**LEVY NUCLEAR POWER PLANT, UNITS 1 AND 2
DOCKET NOS. 52-029 AND 52-030
RESPONSE TO REQUEST FOR ADDITIONAL INFORMATION LETTER NO. 032 RELATED TO
VIBRATORY GROUND MOTION**

**Levy Nuclear Power Plant Units 1 and 2
Response to NRC Request for Additional Information Letter No. 032 Related to
SRP Section 2.5.2 for the Combined License Application, dated May 8, 2009**

RAI 02.05.02-18 Figure 1 Mean hazard curves for the New Madrid and Charleston sources of repeated large-magnitude earthquakes.

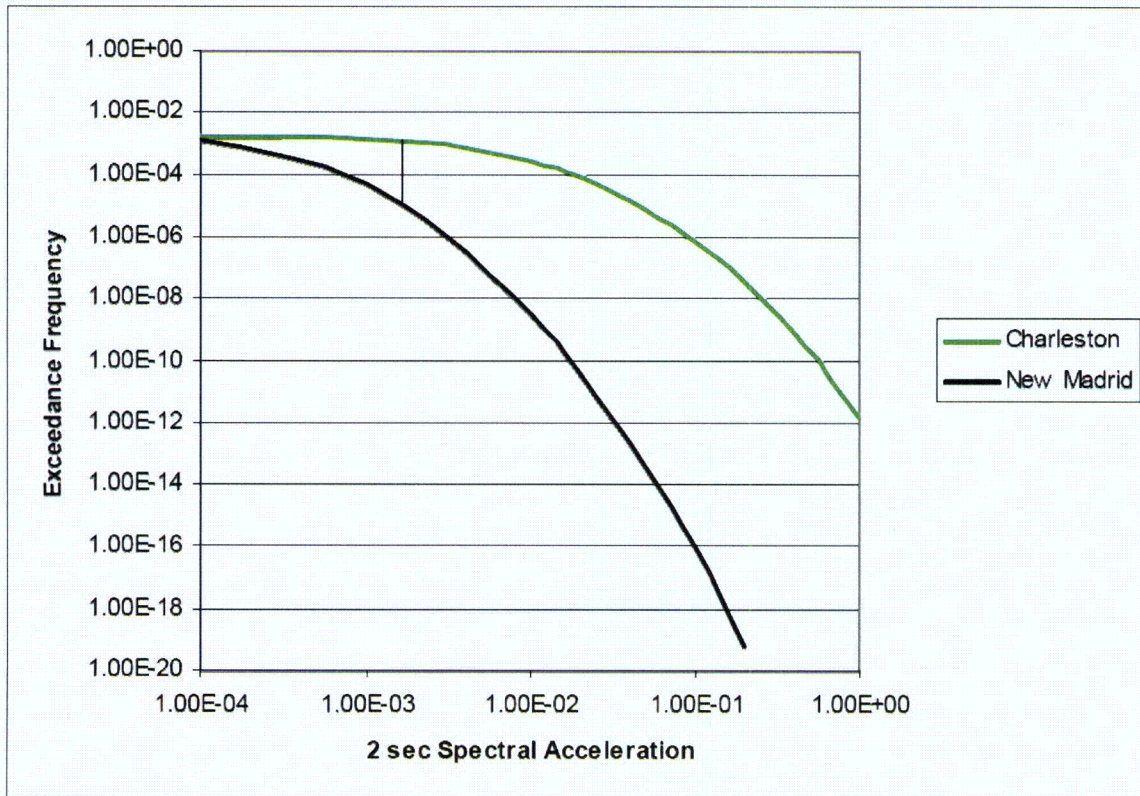
Section 2.5.2.2 (beginning on p. 2.5-98) evaluates seismic sources that contribute to the seismic hazard of the LNP site. The New Madrid Seismic Zone (NMSZ) is considered a major seismic zone in the Southern U.S., however, the FSAR provides no calculation of the contribution of the NMSZ to the hazard at the LNP site. However, the Dec. 1811 New Madrid Earthquake is included in the Appendix 2AA Earthquake Catalog on page 2AA-2.

Please discuss the significance of the NMSZ to the LNP site and provide justification for not including this source zone in the seismic hazard analysis.

The significance of the New Madrid seismic source to the hazard at the LNP site was evaluated as part of the assessment of the appropriate set of seismic sources to include in the PSHA. The tests were conducted using the characterization of repeated large earthquakes at New Madrid defined in Enercon Services (2004) (Reference RAI 02.05.02-18 01). As can be seen on Figure 2.5.2-201, the travel path from the New Madrid region to the LNP site is primarily through the Gulf Coast attenuation region defined by EPRI (1993, Reference 2.5.2-260). Therefore, the Gulf Coast set of ground motion models defined by EPRI (2004, Reference 2.5.2-253) were used to test the significance of the New Madrid seismic source. RAI 02.05.02-18 Figure 1 compares the mean 2.0 second spectral acceleration hazard computed for the New Madrid source to that computed for the Charleston source of repeated large earthquakes. The Charleston source was included in the PSHA for the LNP site. As indicated on the figure, the hazard contribution from the New Madrid source is much less than 1 percent of the hazard from the Charleston source at ground motion levels of importance in defining the GMRS for the LNP site. Tests were also performed for 1 second spectral acceleration using both the Gulf Coast and Mid-Continent EPRI (2004, Reference 2.5.2-253) ground motion models. Again, the New Madrid source was found to have a hazard level at the LNP site that was less than 1 percent of that for the Charleston source at ground motion levels of importance in defining the GMRS.

RAI 02.05.02-19 Figure 1 Comparison of $m_b - M$ relationships.

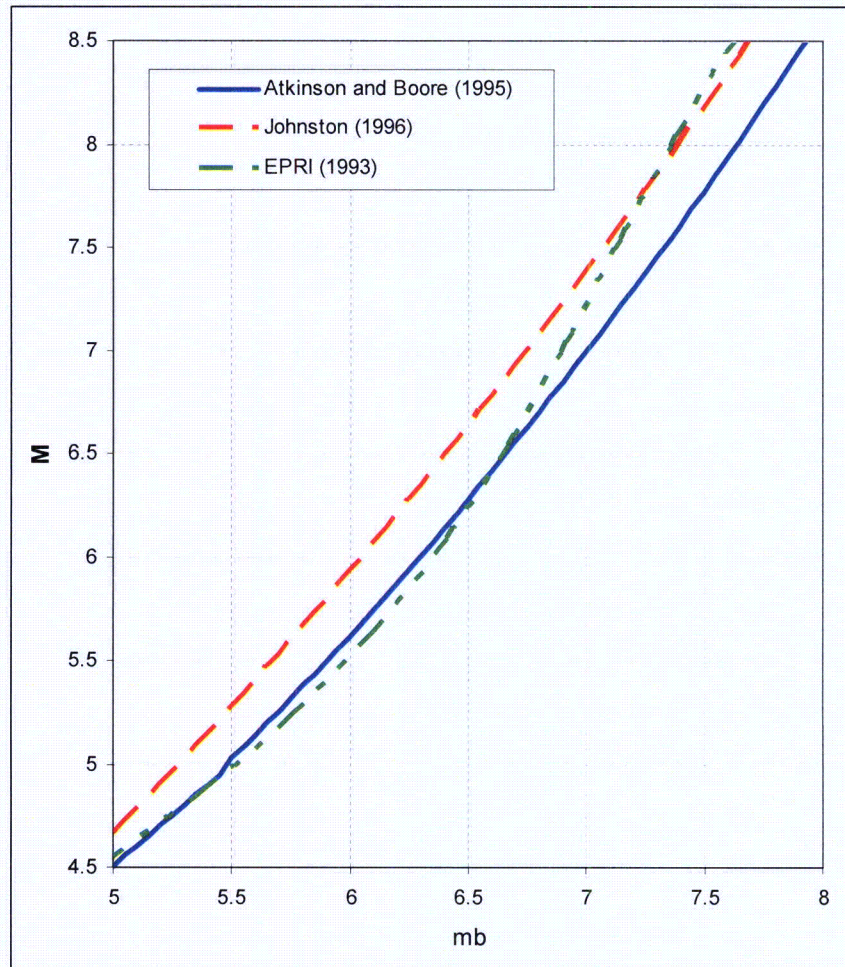
In Section 2.5.2.4.2.3 (p. 2.5-120 to 2.5-121), the FSAR presents three relations used to convert body wave magnitude to moment magnitude. This conversion is important to the PSHA because the magnitudes in the earthquake catalogs are high-frequency body wave magnitudes whereas the ground motion prediction equations use moment magnitude. However, the body wave magnitude scale saturates at $m_b=7$, but the conversion relations do not show the same behavior. For example, when magnitude is set equal to 8, then the Atkinson/Boore, Johnston, and EPRI relations give $m_b=7.6$, 7.4 , and 7.4 , respectively.

Please show plots of the three conversion relations and clarify how you are dealing with the issue of body wave magnitude saturation in the PSHA.

RAI 02.05.02-19 Figure 1 shows these three relationships.

The EPRI-SOG teams defined recurrence relationships and maximum magnitude distributions that extended the m_b scale to magnitudes in the range of 7.2 to 7.5. The magnitude conversions were used in the PSHA to convert these m_b values to M for calculation of ground motion amplitude, accounting for the tendency for saturation in the m_b scale by the curvature in the m_b - M relationships. The primary situation where this conversion has the most impact is in the characterization of the Charleston source of repeated large earthquakes. For that source zone the repeated large earthquakes are characterized in terms of moment magnitude and these estimates are used directly to characterize the ground motions and hazard from this source.
